**From:**  
**Sent:** 04 November 2019 14:02  
**To:** Ailsa Teasdale  
**Subject:** NYM2019/0480/FL The Willows, Low Newbiggin North Farm

**Ref: NYM/2019/0480/FL**

# Proposed Alterations & Extensions, The Willows, Low Newbiggin, Aislaby, Whitby, North Yorks for Mr & Mrs I. Gates.

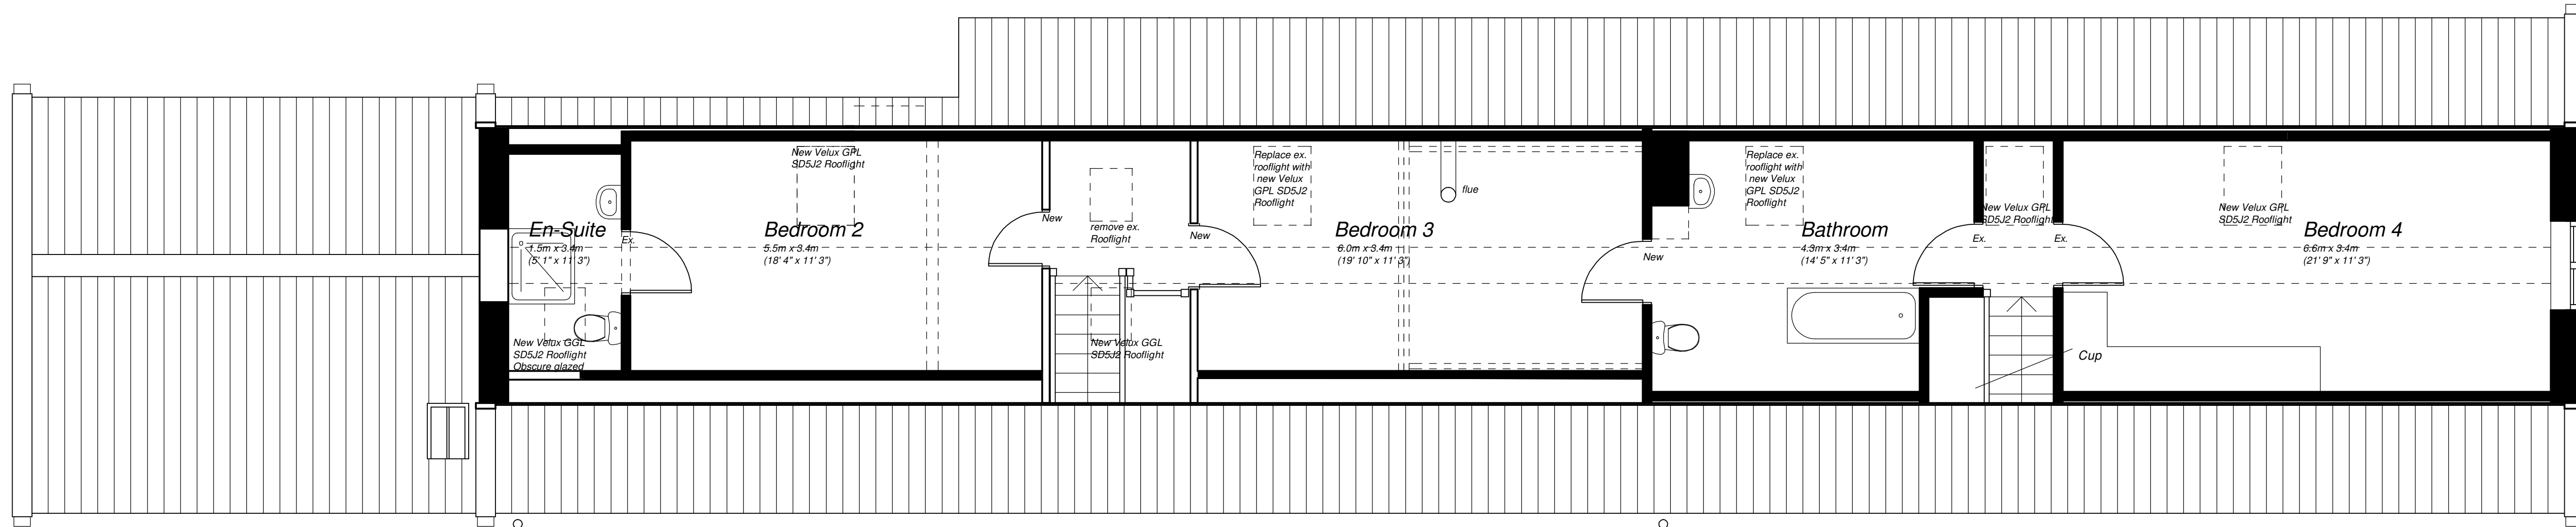
Further to your recent e-mail please find attached a copy of our amended planning drawing no 6029G.19.08D for your approval. We added the missing roof light, on the plan to make five. The rear roof lights are 560 x 980, we have marked the en-suite window as obscure, don't really think the one over the stairs needs to be obscure. We confirm the five front roof lights are 780 x 1400.
